## DESCRIPTIVE REPORT (HYDROGRAPHIC)

Type of Survey .. HYDROGRAPHIC ..  
Field No. .... WH-40-1-73 ..  
Office No. .... H-9144 ..

State ..... GEORGIA ..  
General Locality .... OFF. SAVANNAH ..  
Locality ... TYBEE ROADS. TO. SAPELO SOUND ..

H-9144

PRE-SURVEY REVIEW ITEM  
WH-240 H-9144 (WH 40-1-73)

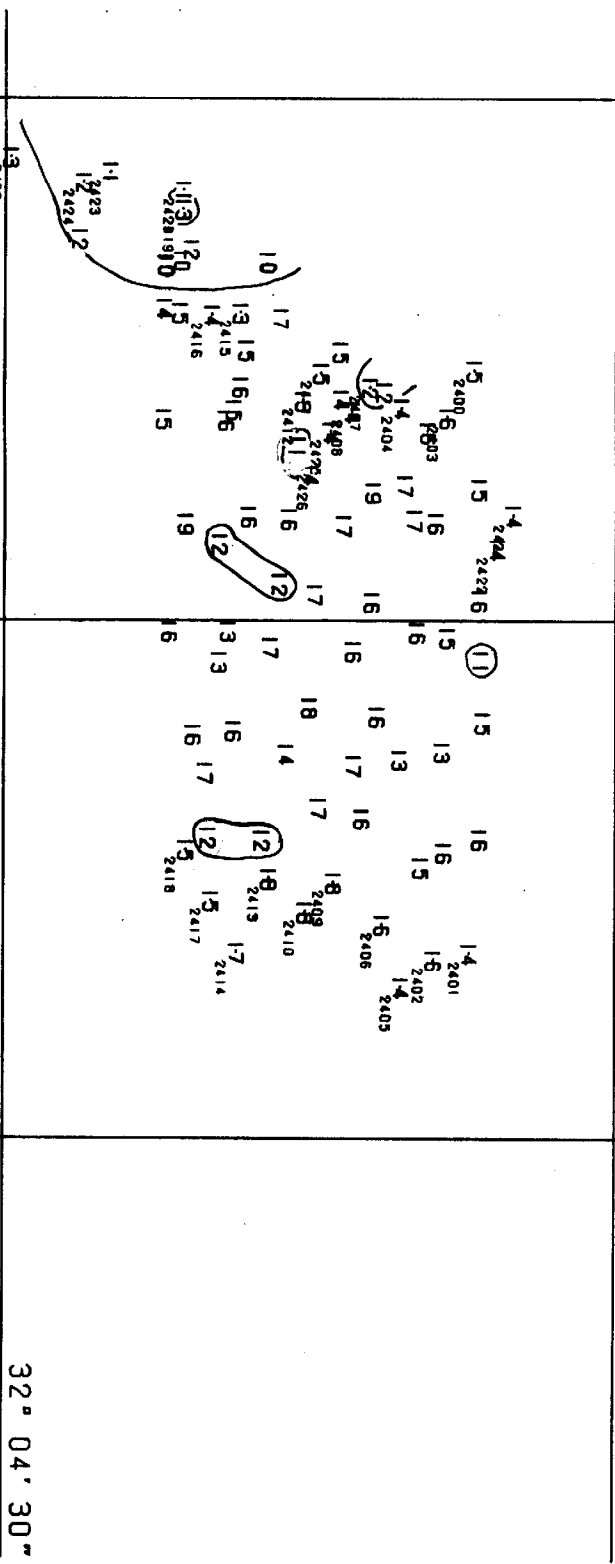
This item was searched for on Julian Day 240 by WH-2. An ~~eight~~ eight foot sounding was found just west of the given position at Lat. 32°04'.70N, Long. 080°40'.83W. The hydrographer recommends charting the eight foot sounding at the position determined by the survey. *Shoalest depth in the area ~~is an 8-ft sounding located at lat. 32°04'.58', long. 80°40'.83'~~*

PRE-SURVEY REVIEW ITEM 7  
 H-9144 (WH40-1-73)  
 POSITION NO'S 2300 - 2324  
 SCALE 1:10,000

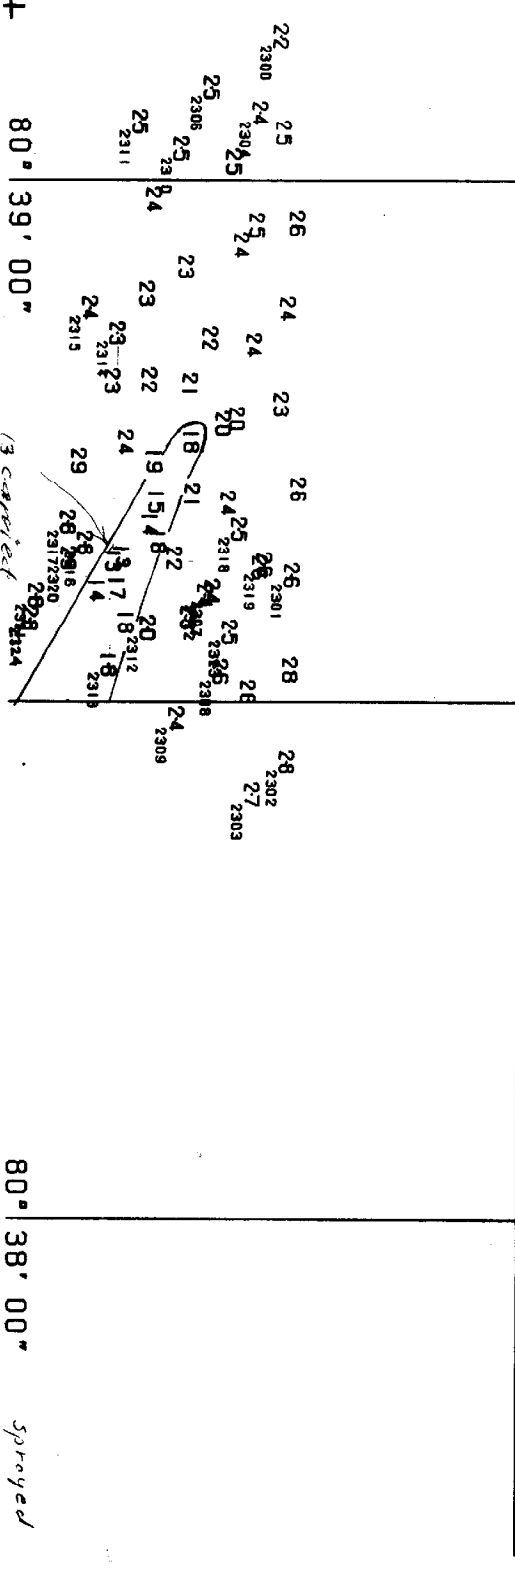
This item was searched for on Julian Day 239 by WH-2. An 11 ft. sounding was found to the southeast of the given position at Lat. 32°04'.17N, 080°38'.63W. The hydrographer recommends charting the 11 ft. sounding at position determined by the survey. <sup>13</sup> *from 2313-2314 vessel 2932* **CONCUR**

*13 corrected  
 returned to main sheet*
